Benton County Planning Board

**Benton County Development Department-
Planning Division**

**SITE PLAN REVIEW – MAJOR AMENDMENT
PLANNER’S PUBLIC HEARING REPORT
21153 AR HWY 16, SILOAM SPRINGS, AR, 72761**

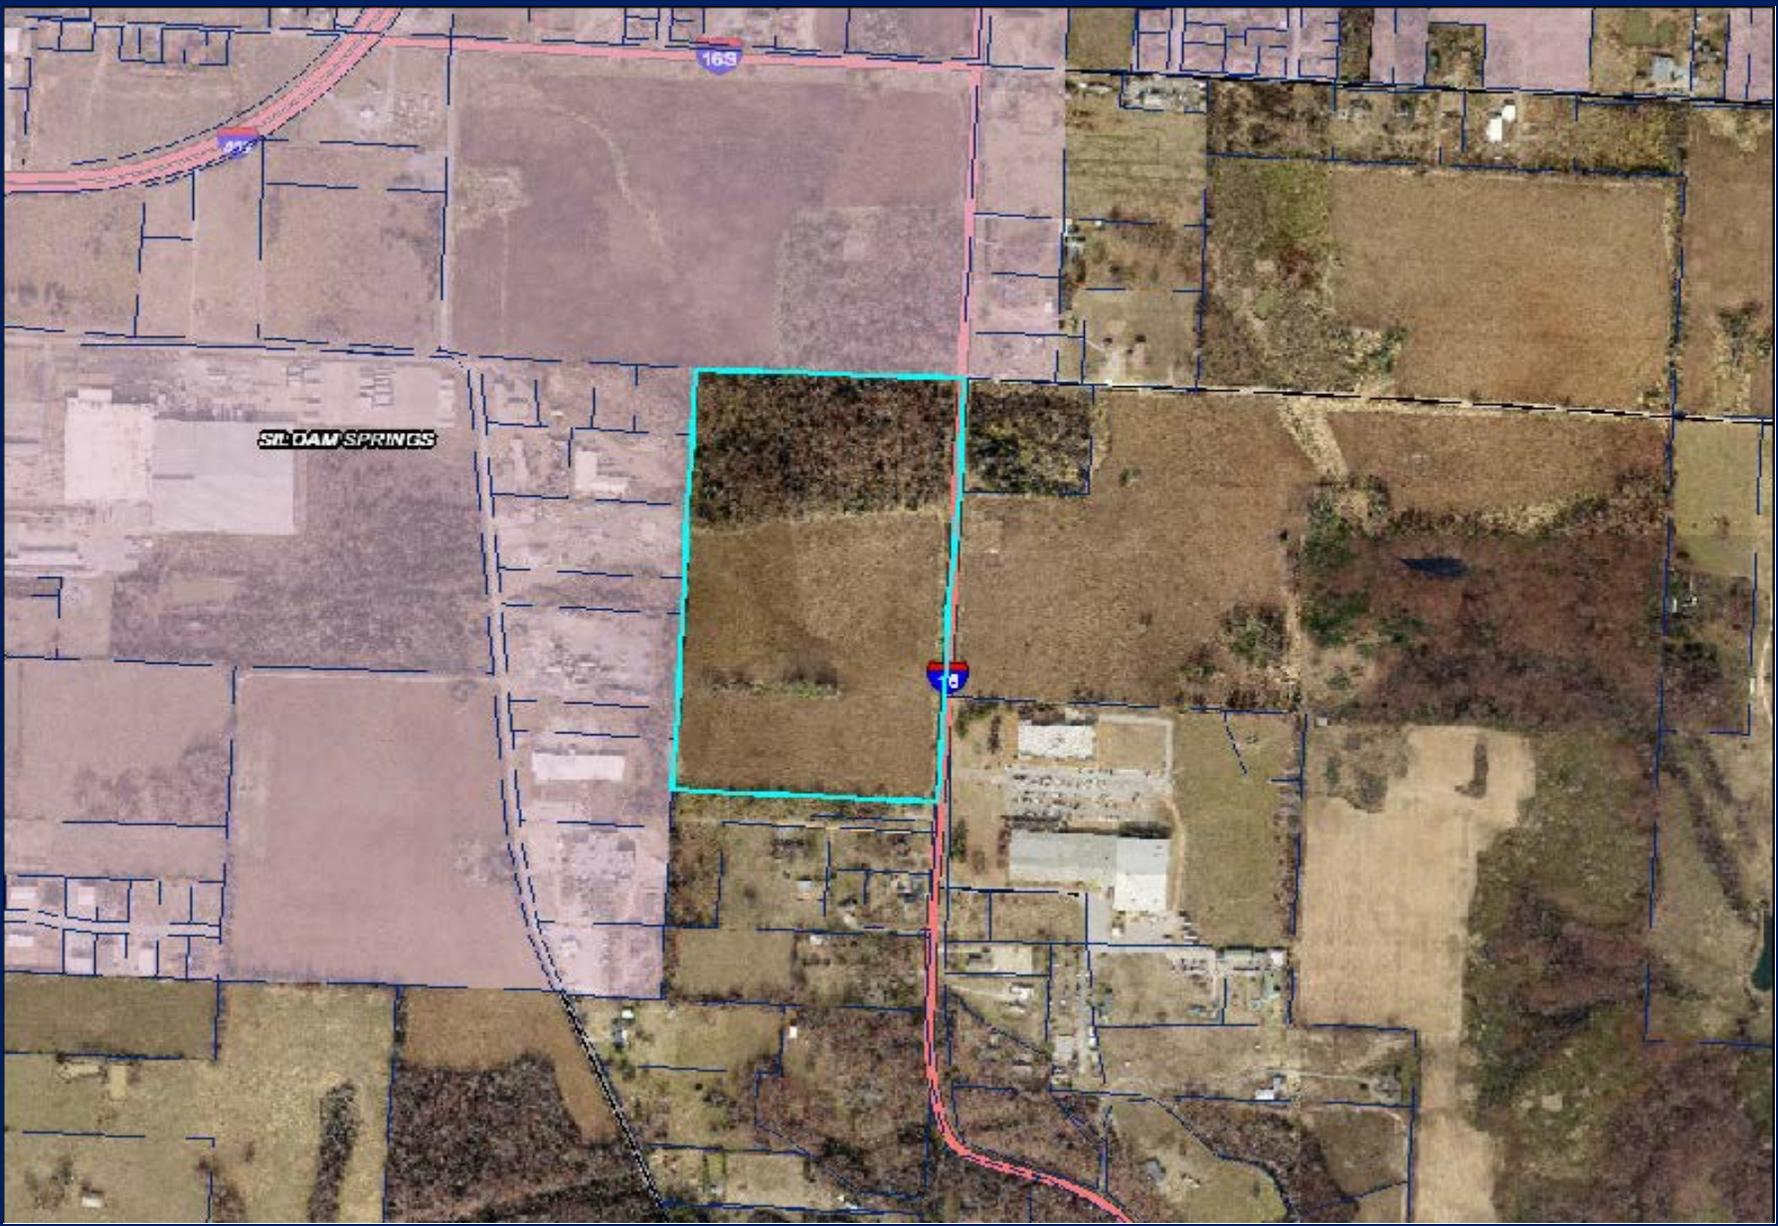
The proposed (amended) landscaping plan for the southern berm details a series of Leyland Cypress 15ft on center with Glen St. Mary leafy evergreens placed at the midpoint of each Leyland Cypress. The southern earthen berm is shown to have a finished constructed height of 16ft. at the western end (cross section 3) and 8ft. in height at the eastern end (cross section 2) of the berm. (See attached landscape plan)

The proposed (amended) landscaping plan for the eastern property line (frontage) along Hwy 16 details an area of landscaping in the center of the property. (See attached landscape plan)

1. The applicant provide signed Landscape Architect endorsement on Landscape Plan prior to issuance of Planning Board decision letter
2. The applicant provide amended civil engineering plans of 2014 Site Plan Review approval with reference to the amended 2015 Landscape Plan.
3. Applicant agrees to Standard Conditions
